STATE OF NEW HAMPSHIRE

INTER-DEPARTMENT COMMUNICATION

SUBJECT: (Response to RFMI)
Dummer, 16304A
DES#2018-00986

RE: Response to request for reconsideration of the wetland mitigation assessment and Request for More Information; NHDES File # 2018-00986
NH Rt. 16, Dummer, NH (16304A)

Table #3 - Wetland and Stream Culverts

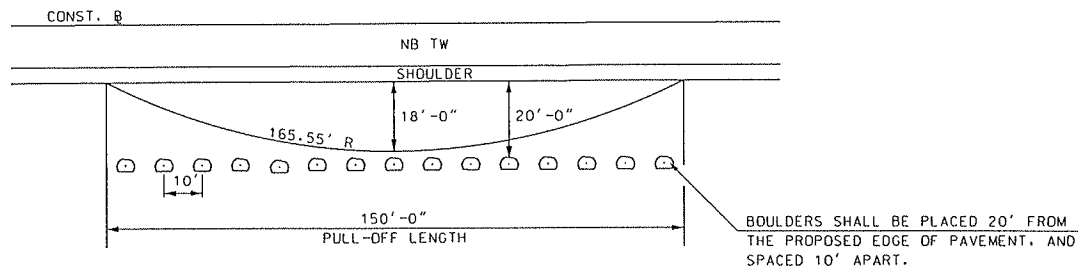
1. Please provide full size plans by VHB printed to scale with existing and proposed contours which are labeled and readable.
2. Appendix M- SRE Wetlands Report Pages M-79 to M-90 are plans that include duplicate pages, duplicate half pages, are out of order and is missing Sheet 1 of 6. Provide a new, complete set of plans.
3. Appendix B states Mitigation Report/ Coordination/ ARM Calculator. Only the ARM calculator was included in Appendix B. Please provide the remaining information.
4. Table 3 Wetland and Stream Crossings. Many locations noting crossings by road stations are inaccurate. Please correct and replace the table.
5. Please provide plans for re-vegetation of all disturbed soil areas.

4. In review of Table 3. Wetland and Stream Culverts it was determined that the table has two minor areas that would benefit from clarification. Other than that there was no inaccurate information. The table accurately references the station #'s, the size of the existing pipes, and the size of proposed replacement pipes. The first of two areas for improved clarification is in Row EX-3 where the location station indicated 1002+5X it should have read 1002+50. The second row of information that would benefit from clarification was EX-8. This row of information noted the existing 15" CMP at Station 1023+33. However, the proposed 18" RCP is shown on the plans to be relocated further to the north at Station 1024+50. No other errors were found in the table. Please find the attached table that has been edited to address these two revisions.

*** 18" RCP Relocated to Station 1024+50**

Proposed Pull-off Details

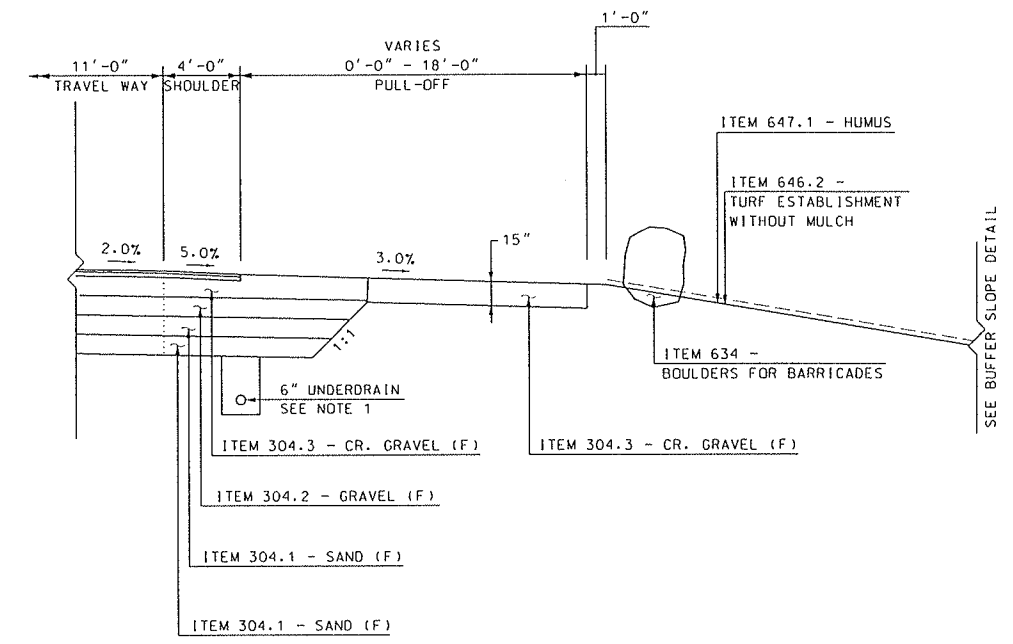
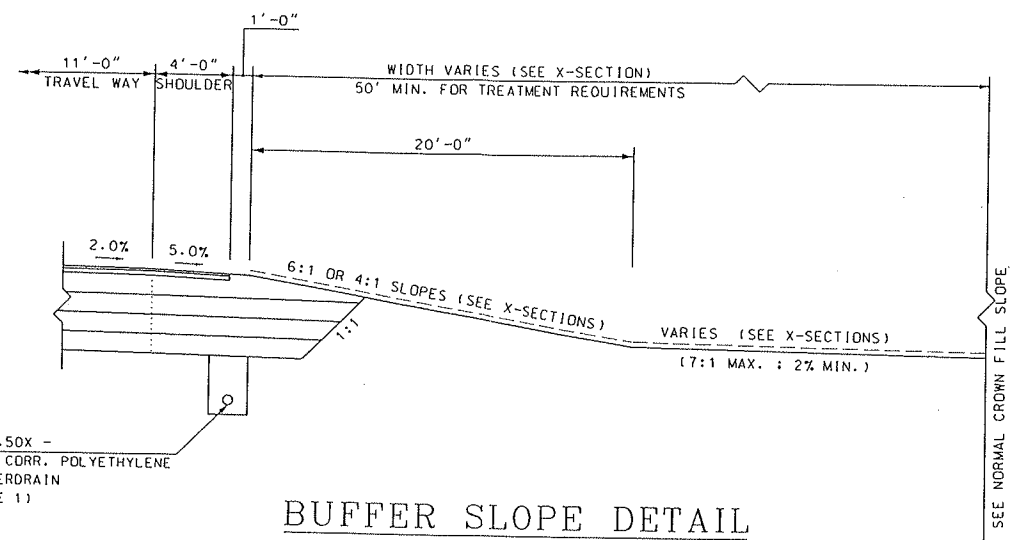
11. Plans include a note, "Proposed Pull Off Location" (see detail) however, no detail was found in the plans. Please provide that detail.

9. In review of the wetland impact plans, Station 1032 to 1033 DOT was not able to locate the "errant lines" that are alluded to. We do see several intentional wetland classification leaders that point to the specific wetlands that are impacted so the Cowardin classification of the wetlands is clear.
10. In review of the wetland impact plans, Station 1050, DOT was not able to locate the "erroneous wetland delineation lines" that are alluded to. The wetlands shown on the plans were delineated by a Certified Wetland Scientist (CWS): Stoney Ridge Environmental. As such, we are not comfortable adjusting/deleting wetlands shown in this area.
11. Please find the attached detail for the proposed pull off locations as requested.
